3.4 Municipal Station #4 – 10 Lisgar Avenue

**4.0 CONCLUSIONS**

**5.0 ACTION LIST**

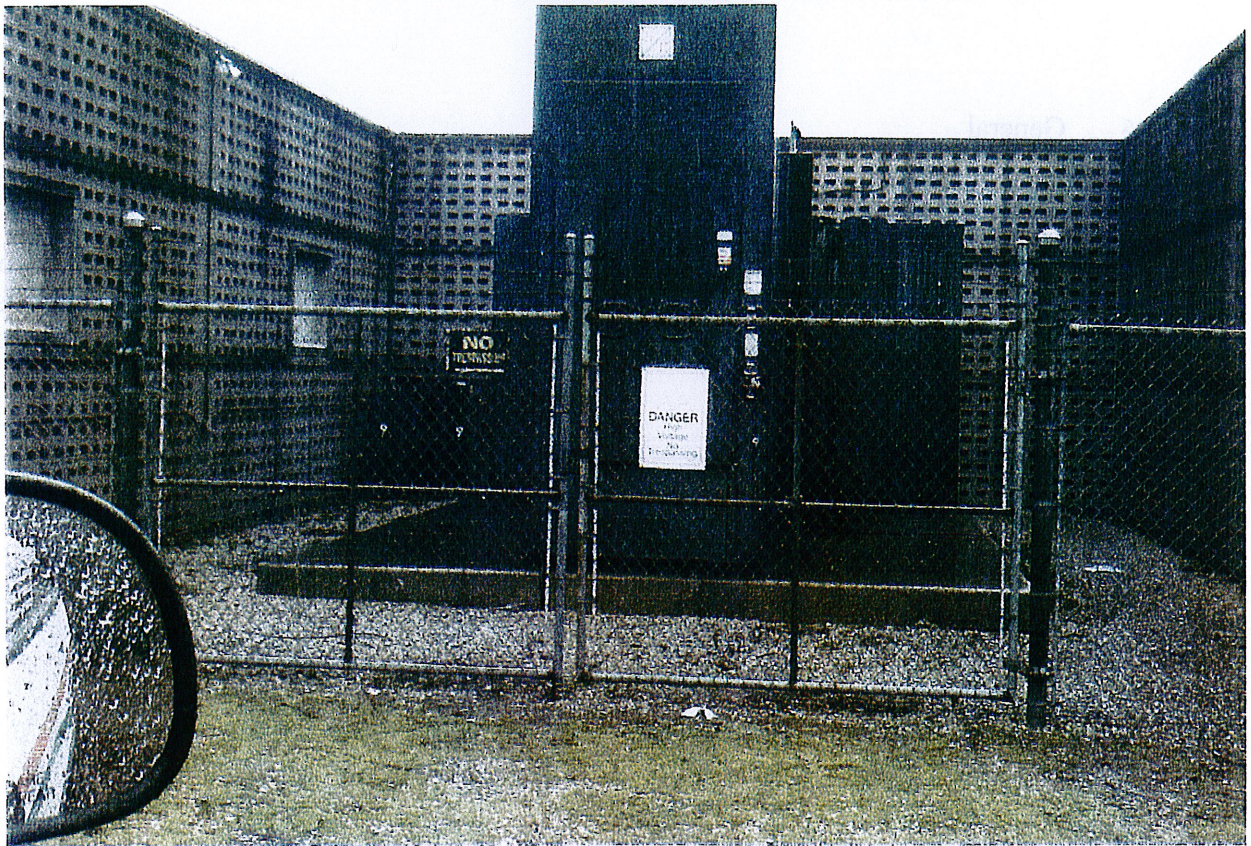
- There is a 5000 kVA transformer located here, 27.6/4.16 kV, 1975 vintage.
- Impedance: 5.49%
- This station supplies four 4.16 kV feeders, via fuses.
- We were unable to determine the size rating of the 27.6 kV fuses.
- Warning and location signs should be added to the gate and fence.

- This station is located in the back yard of the storage-garage building. The gate to the structure is left open during working hours. We believe this is a risky situation, which could be corrected by either adding remote control to the rear gate, or fencing the substation separately.
- There is a propane tank located in this yard as well, which is apparently slated for removal.
- Spill containment curb has been added around the transformer.
